**Technical Service
BULLETIN**

SQUEAK NOISE FROM EXHAUST JOINT

'04 – '05 Sienna (2WD Only)

ENGINE
EG011-05

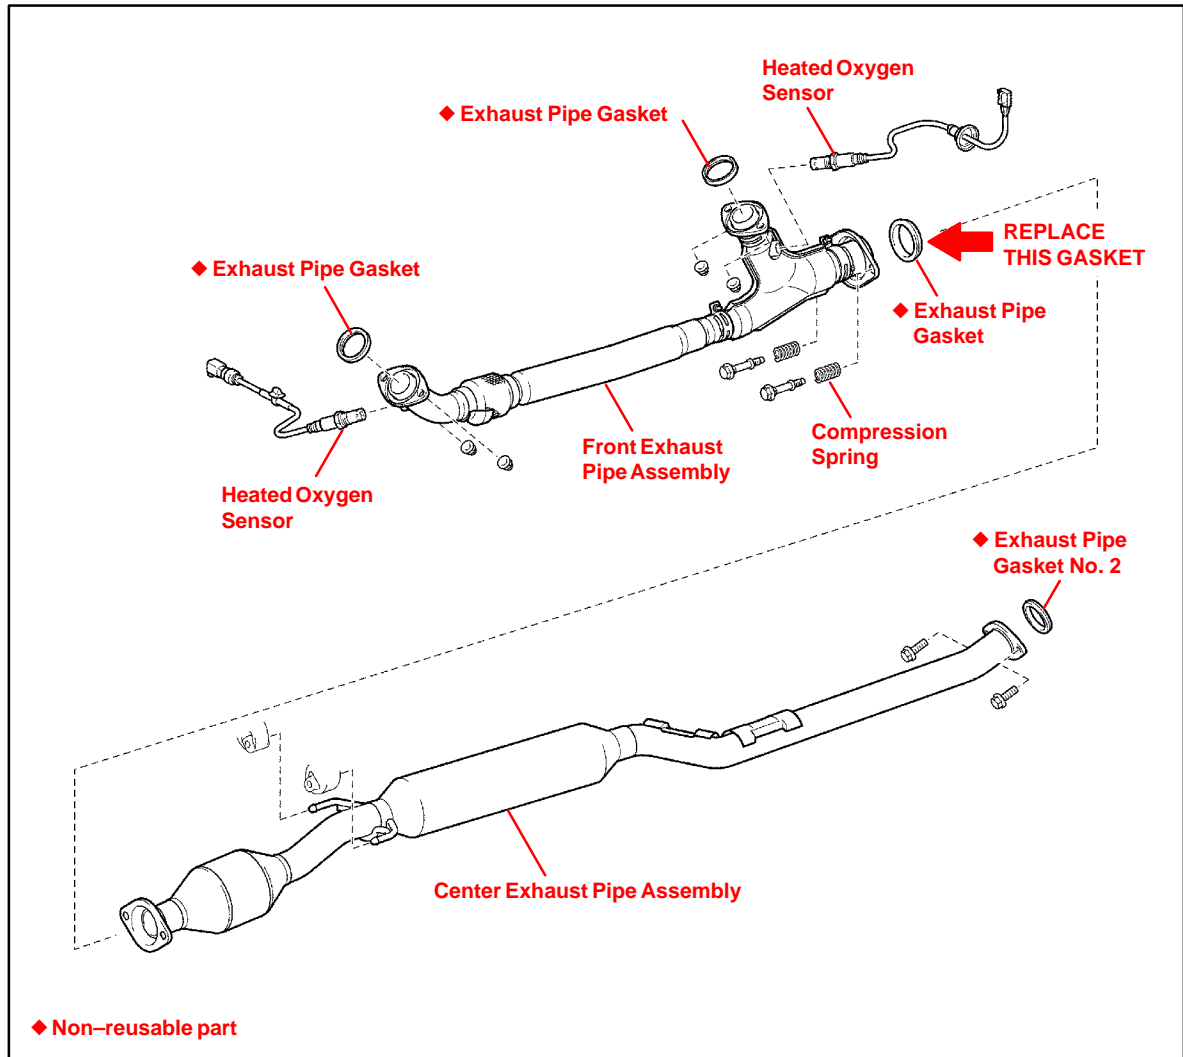
Introduction Under certain driving conditions, some 2004 and 2005 model year 2WD Sienna vehicles may exhibit a “squeak” or “creak” noise from the flexible joint in the exhaust system. A revised exhaust gasket has been developed to reduce the noise.

1. Confirm squeak noise is coming from exhaust system flexible joint between front exhaust pipe and center exhaust pipe. (See illustration for location of exhaust gasket.)

5. If the flexible joint makes a squeak noise replace exhaust gasket with new exhaust gasket (P/N 17451-0D020).
6. Refer to the Technical Information System (TIS), 2004 or 2005 model year Sienna Repair Manual: *Exhaust: Exhaust Pipe Assy (FF): Removal & Installation And Disassembly & Reassembly* to remove and replace exhaust gasket between front exhaust pipe and center exhaust pipe assemblies.
